## ADDENDUM

**PROJECT:** Jefferson Community Health Center  
Patient Wing and Administration Renovation  
Fairbury, Nebraska

AD-3

**DATE ISSUED:** Wednesday, January 30, 2013

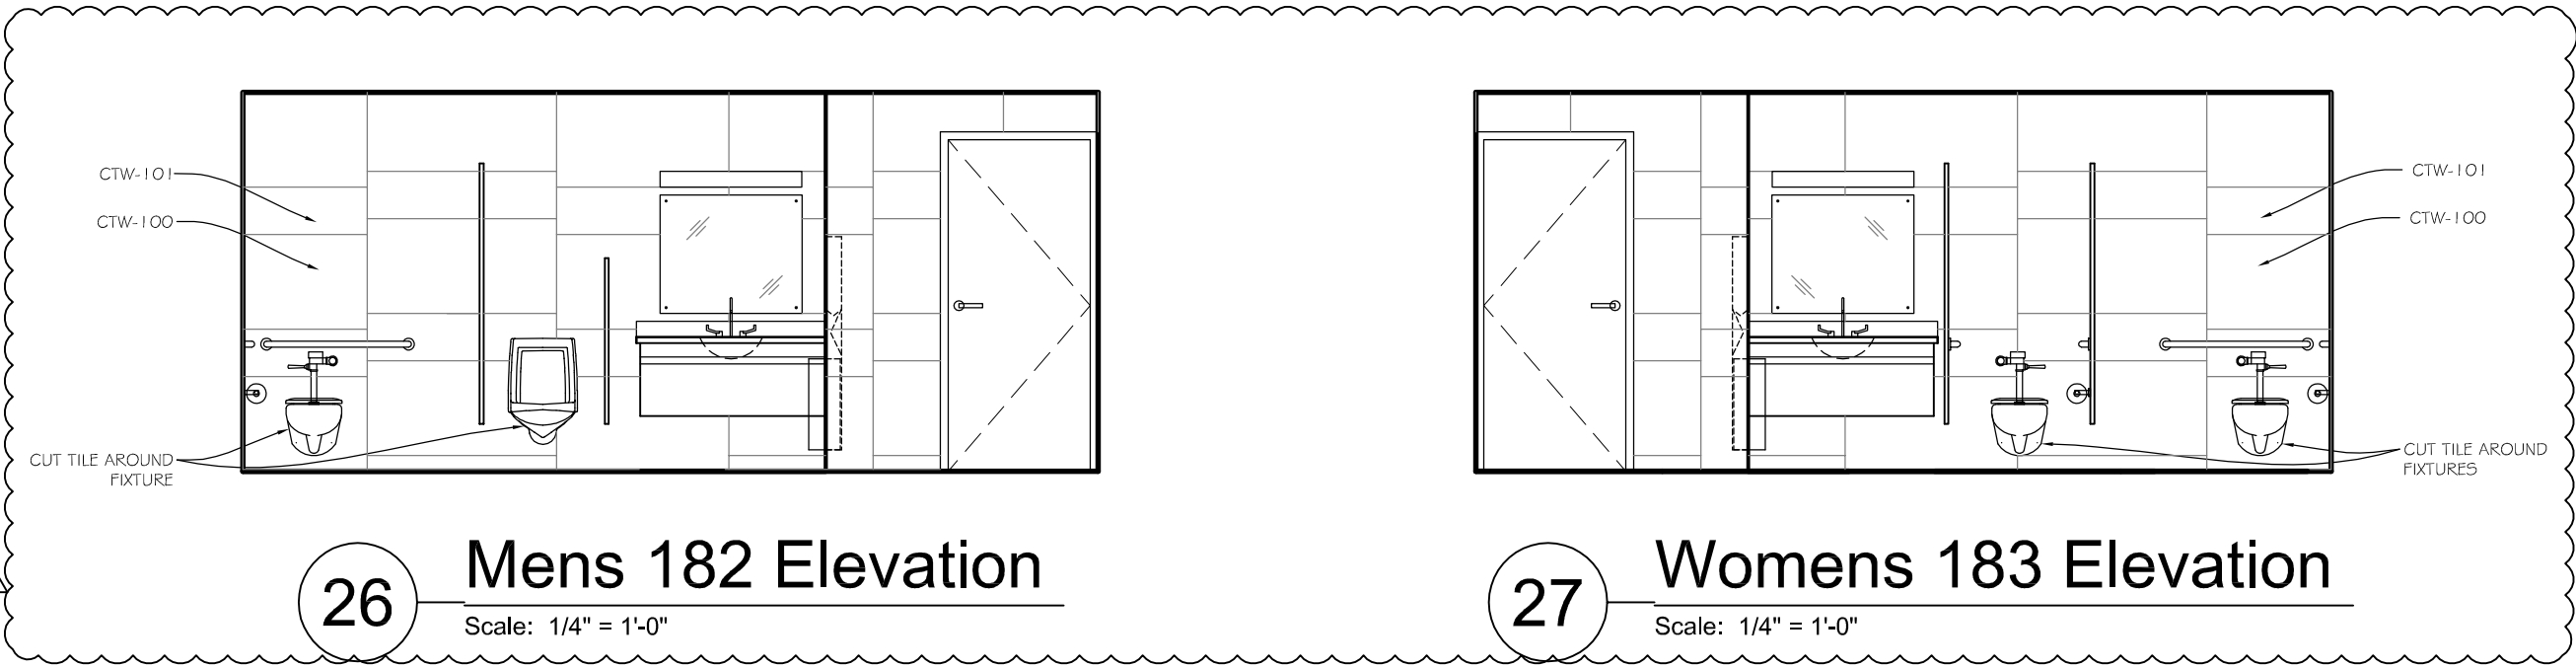
In reference to **Sheet A-203**, see attached Sheet A-203.2 for revised tile elevation for rooms 182 and 183.

**26** Mens 182 Elevation  
 Scale: 1/4" = 1'-0"

**27** Womens 183 Elevation  
 Scale: 1/4" = 1'-0"
